**Stantec Consulting Services Inc.**  
12080 Corporate Parkway, Suite 200  
Mequon WI 53092-2661

December 2, 2022  
File: 193707141

**Reference: Response to Request for Additional Information #2; Materials Management Plan and Ch. NR 718 Exemption Request for C. Reiss Coal Dock Property, Superior, Wisconsin, BRRTS Case No. 02-16-589248**

SHEET ID  
**C-103**

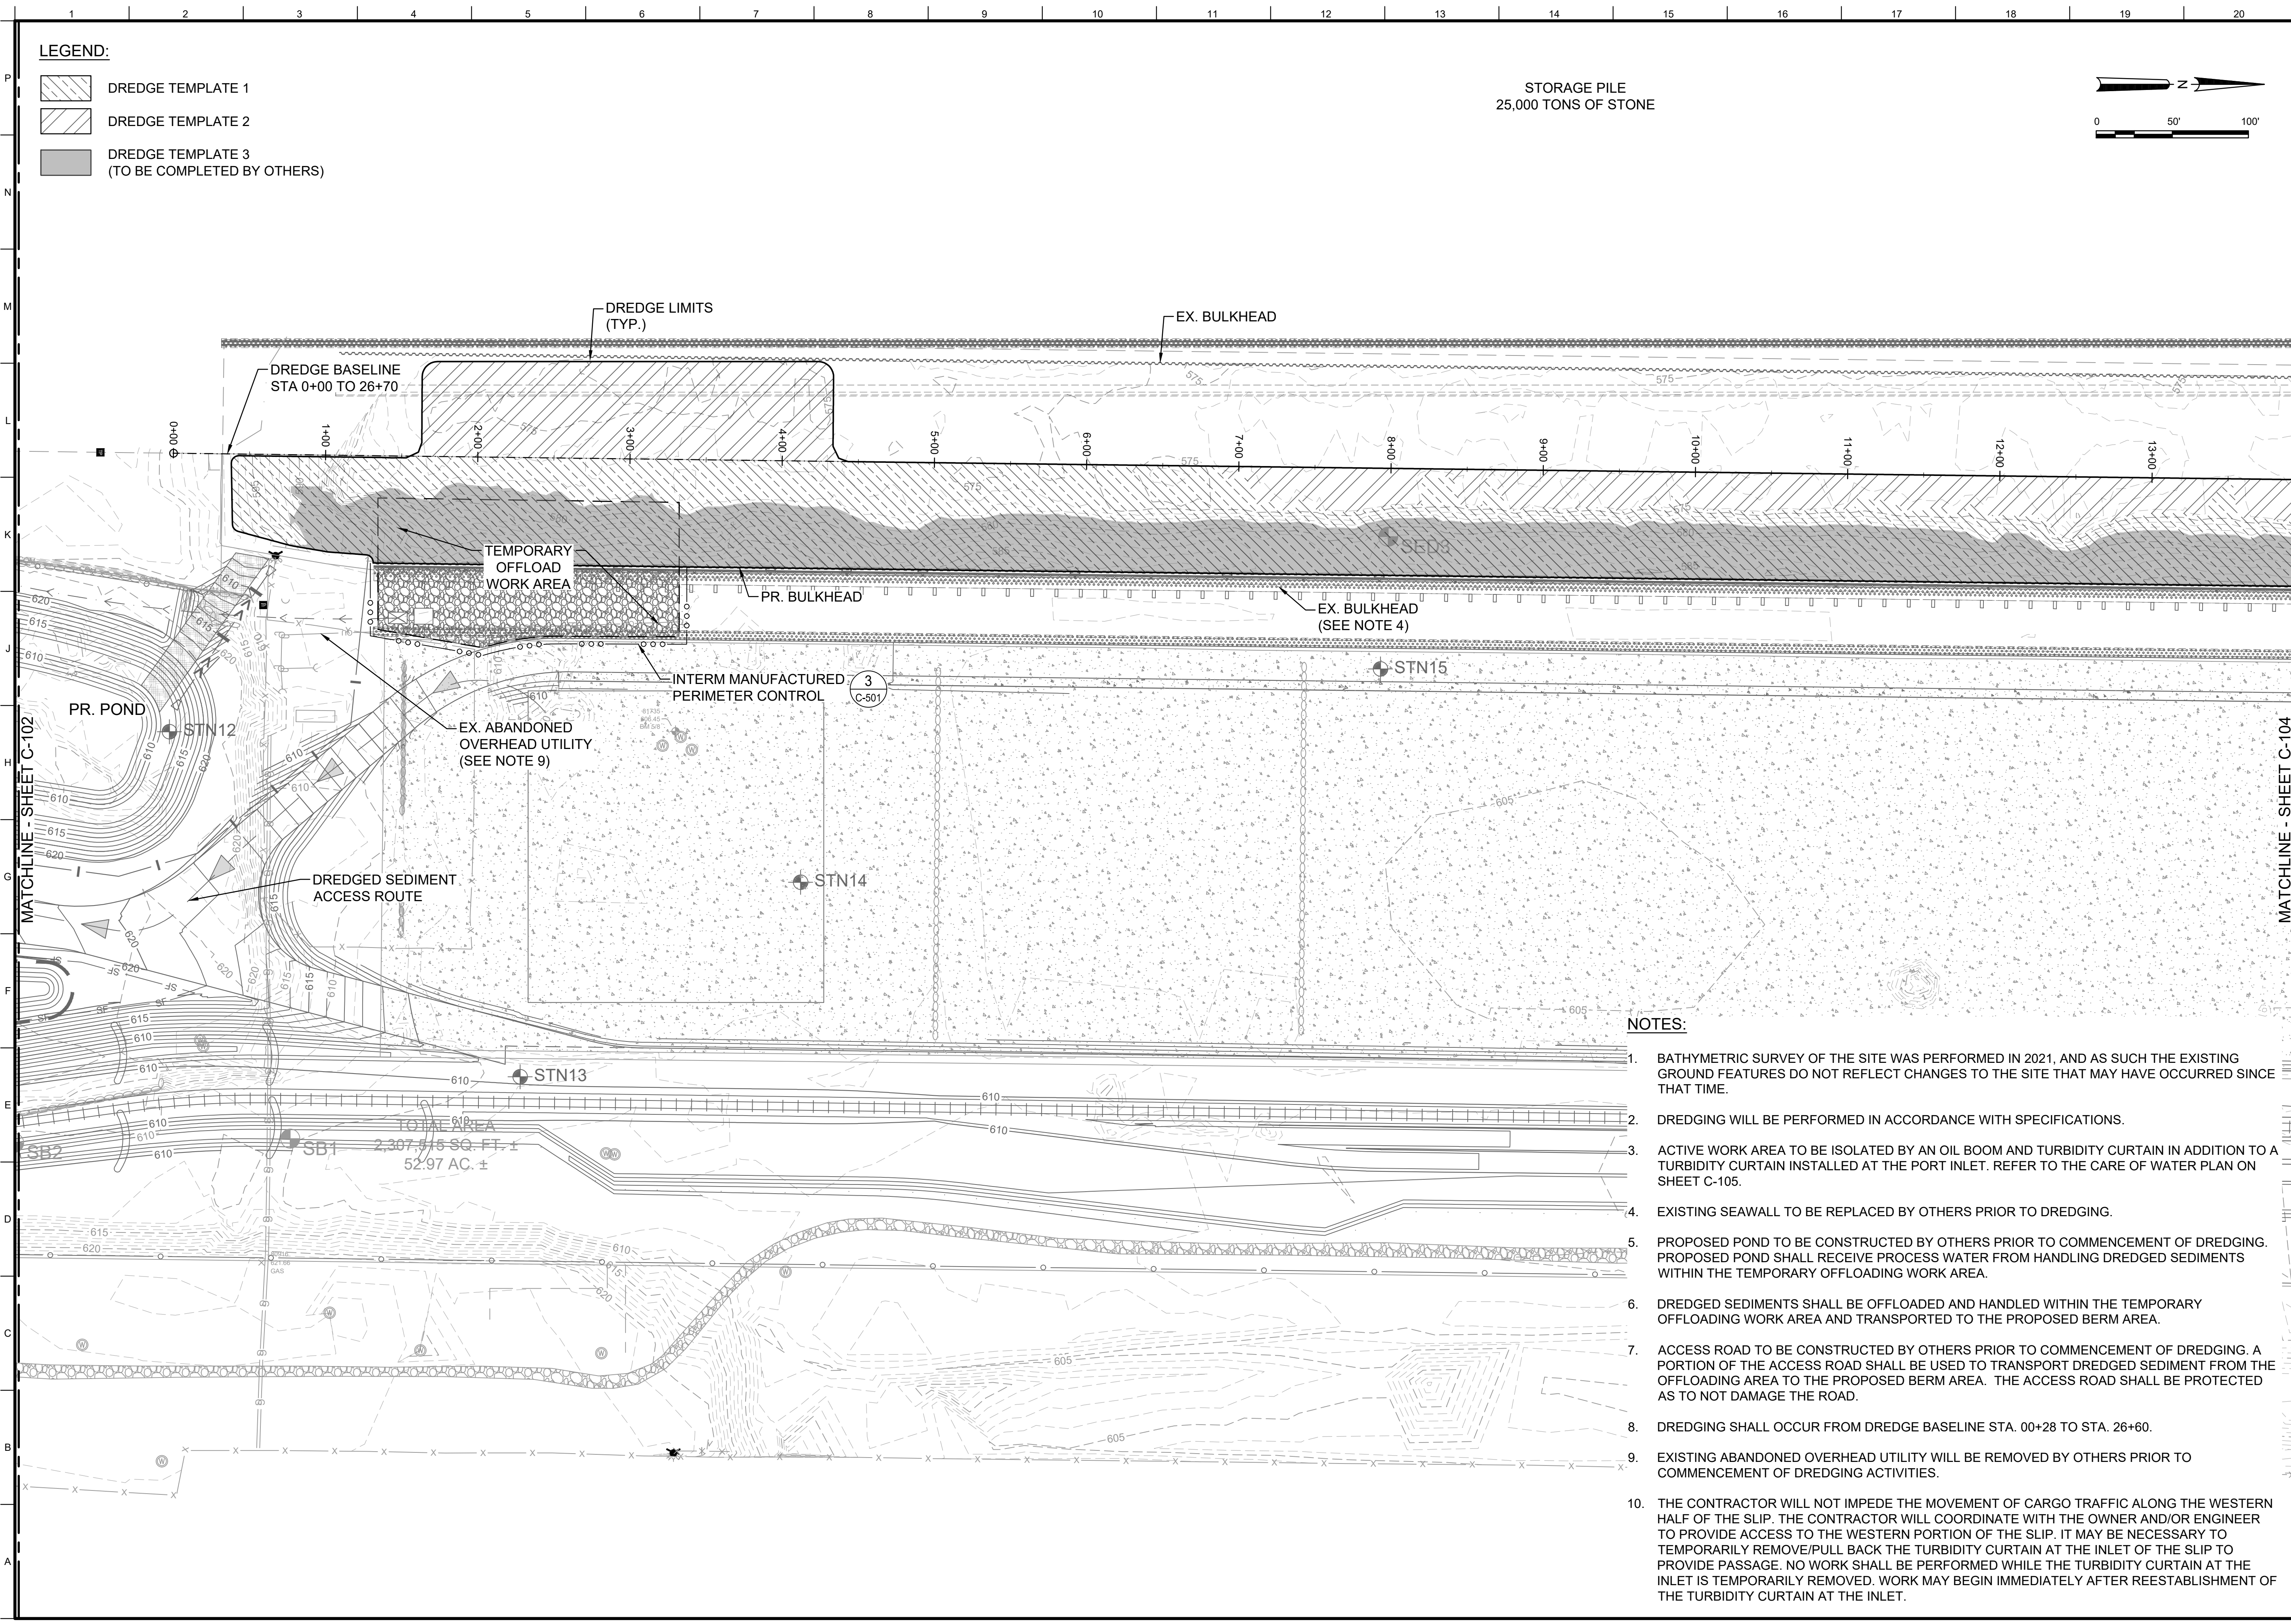
**9. Dredging sheet C-103 (30%) appears to show a culvert entering the stormwater pond from the ditch adjacent to the railroad grade. This feature is not shown on other sheets. Is a hydrological connection between the ditch and stormwater pond be needed and will a culvert be installed where shown on sheet C-103 (pdf page 192 of 535 in Stantec response)?**

**Response:** The culvert entering the stormwater pond from the ditch adjacent to the railroad depicted on Dredging Sheet C-103 of the 30% Preliminary plan submitted as part of the Stantec (2022b) *Response to*

*Request for Additional Information* was depicted in error, as this feature has since been removed as project planning has progressed. An updated Dredging Sheet C-103 (90% Preliminary plan) is included as **Attachment A**. With construction as proposed, no hydrological connection between the ditch and stormwater pond is needed.
